Concession Application 64177-ACC Request for Further Information

Thank you for your letter dated 10 May 2018 requesting further information. Please find the response below.

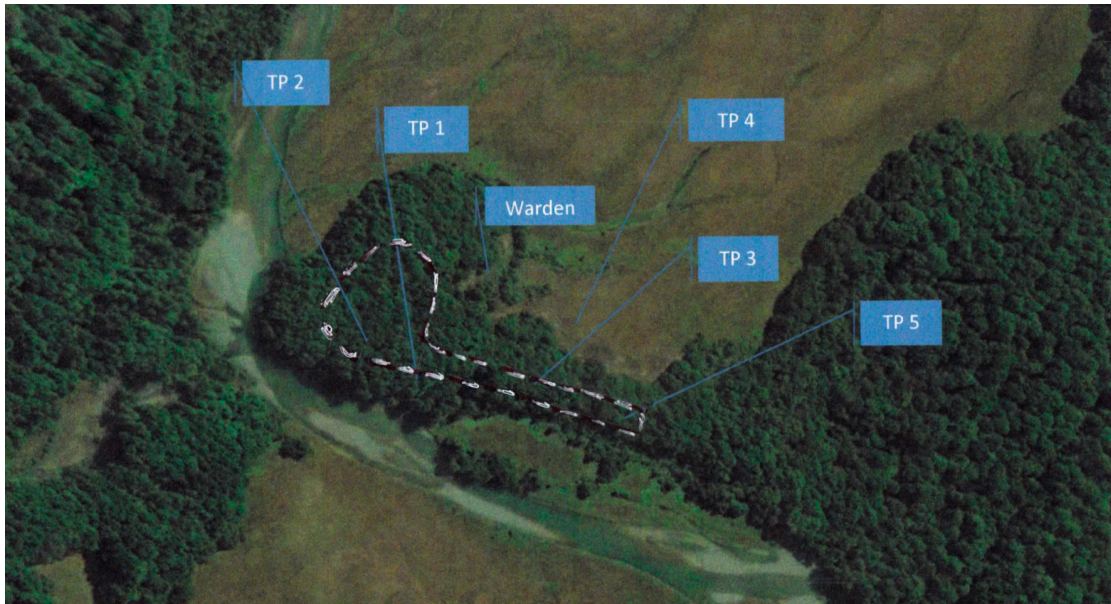
1. *An aerial map(s) showing:*
 - a. *The size and location(s) of the grey and black water treatment system options being proposed*

Since submitting the concession application, we have done further work on the wastewater system and are considering treating both greywater and blackwater on site, as opposed to removing blackwater from the National Park.

Preliminary investigations suggest that the land is well suited to a subsurface dripper irrigation system. At this stage, we would propose that approximately 2000 m of dripper lines would be laid in modules in an area of open forest, elevated and away from the river, as indicated on the map below:

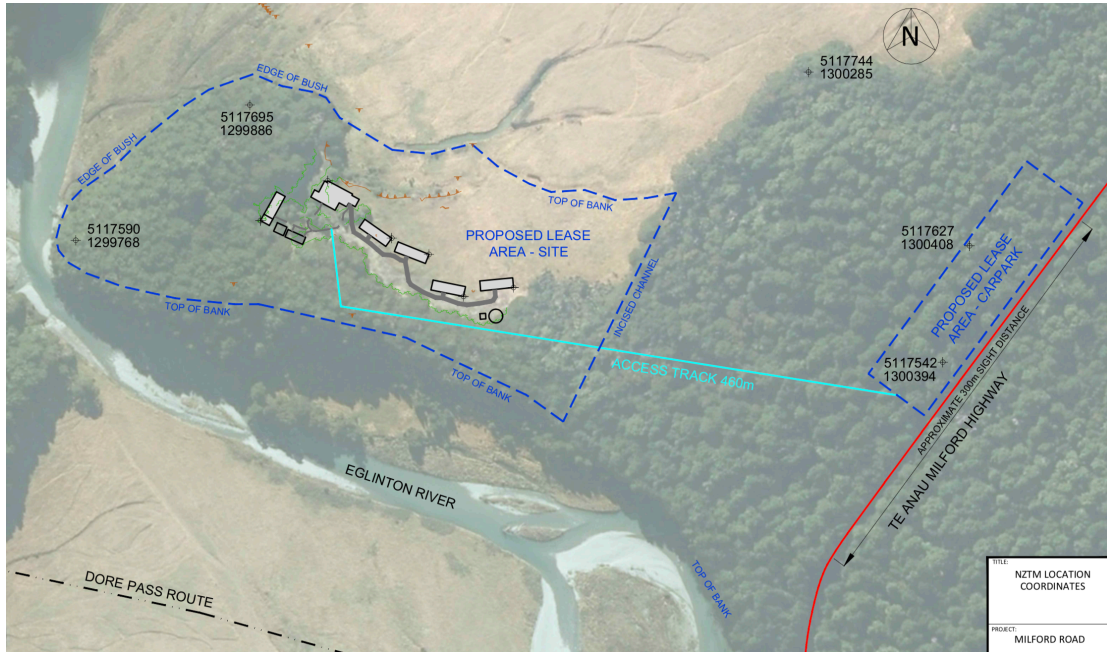
- b. *The size and location(s) of the carpark being proposed to include the desired line for the access track between the carpark and accommodation facilities*

The Milford Road Alliance, the group charged with maintaining the Milford Road, have confirmed that any entry/exit point on a State Highway with a speed limit of 100km/hr must be a minimum sight distance of 282m from a corner. As a result, we have extended the space required for the carpark so that the entry/exit point meets this requirement.

As previously indicated, the intention is to form a carpark for 30 cars. It would be similar to the Lake Marian carpark in that as much as possible mature trees would be left in place and the carpark is formed in a sensitive manner taking into account existing trees. It also allows for the utilisation of space where there is currently debris from trees that have already been felled for road maintenance.

The Access Track is marked on the map below. The proposal is to take a relatively direct route from the carpark to the buildings, while taking into account factors such as gradient, the two incised channels, designing an

aesthetically pleasing route similar to DOC tracks, ensuring wheelchair accessibility and any engineering or track building requirements.

The map at Item 1. b. above, also indicates an alternative to the lease areas submitted in the concession application.
